# The HAMILTON TOWNSHIP ZONING COMMISSION

## PUD Stage 1 Site Plan

### Maineville Plaza

- Owner:** D.J. Patel
- Applicant:** D.J. Patel
- Spokesperson:** D.J. Patel
- Location:** 52 Stephens Road, Maineville, Ohio 45039
- Size:** 6.926 acres
- Zoning:** B-2 PUD

**Site Plan Summary:**

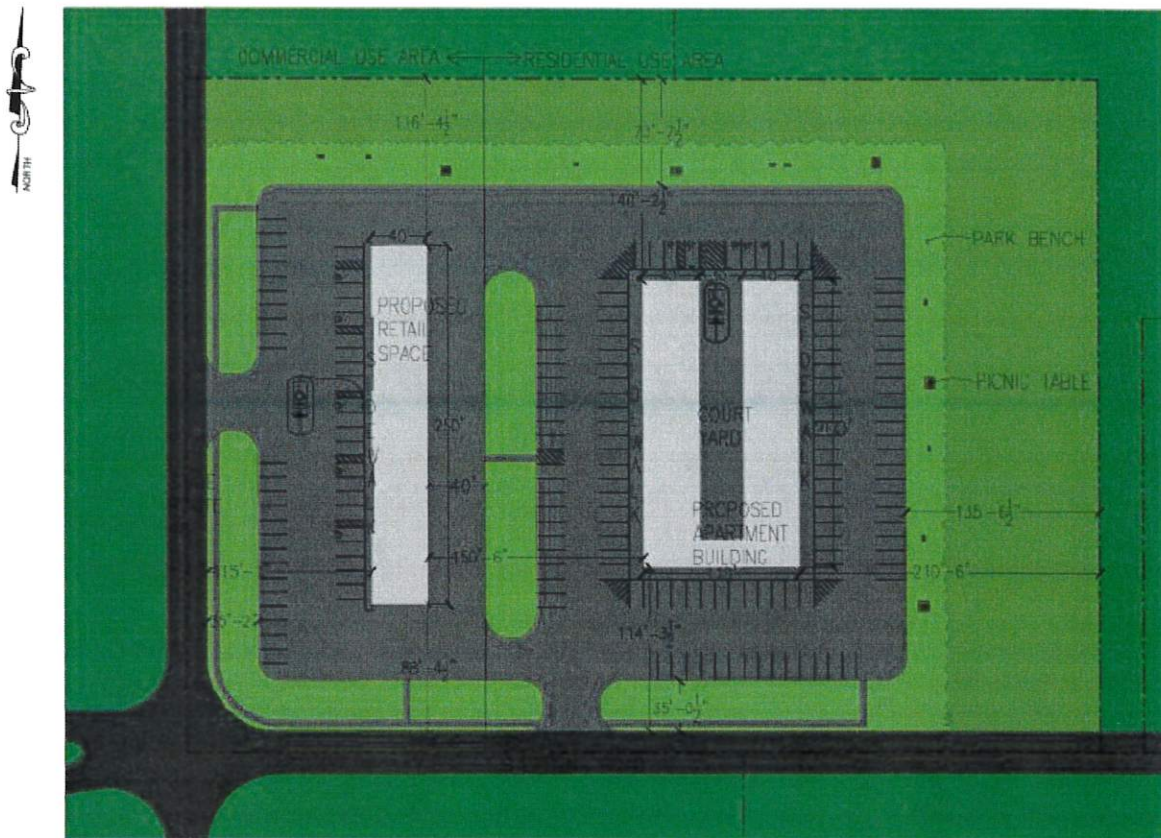
**Note:** The proposed site plan contains 112,916 square feet of vehicular use area. Thus, the HTZC requires a minimum of 5,650 square feet of landscaped area. The Applicant intends to meet the HTZC vehicular use area landscaping requirements by landscaping 2 sections of the property located in between the commercial and residential buildings (as depicted on the site plan) to create approximately 8,336 square feet of landscaped area.

**RPC Recommendation – DENIAL.** Reasoning: In summary, the Warren County Regional Planning Commission viewed the current Hamilton Township Land Use Plan indicates 52 Stephens Road as R-1 Single Family Rural Residential District as a major deterrent to recommending approval.

Staff recommends the Zoning Commission to recommend "Denial" of this proposed plan to the Hamilton Township Trustees based on the incompatibility of multi-family in this area as well as a large amount of public push-back from nearby residents.

Specifically, the smaller-sized apartment layouts for the 1 and 2 bedroom apartments do not align with the Hamilton Township community, and constructing separate buildings for the commercial and residential

uses creates a much larger development footprint than if the two separate buildings were combined into a mixed-use development.

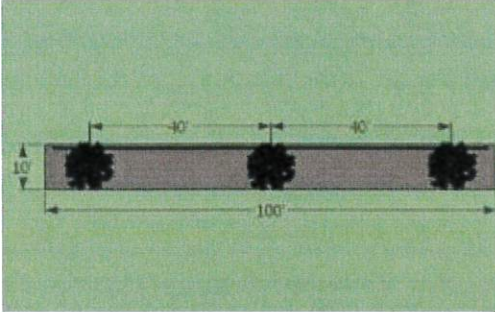
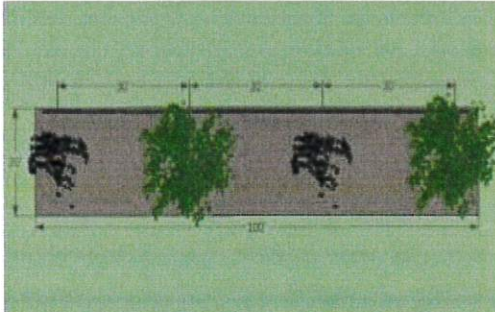
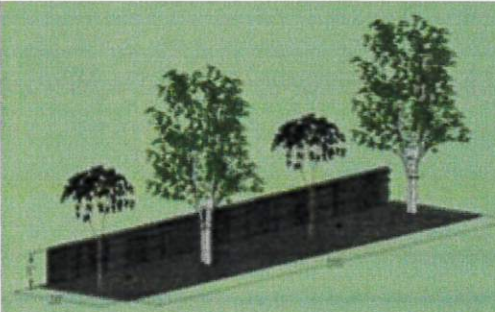
The Hamilton Township zoning inspector shall review and make decisions on architectural features in accordance with the guidelines and standards set forth in *HTZC Section 6.4*. The proposed facade for both the retail building and apartment building is a combination of brick, stone and stucco. The Applicant has provided the following examples to demonstrate the proposed look and feel of the buildings:
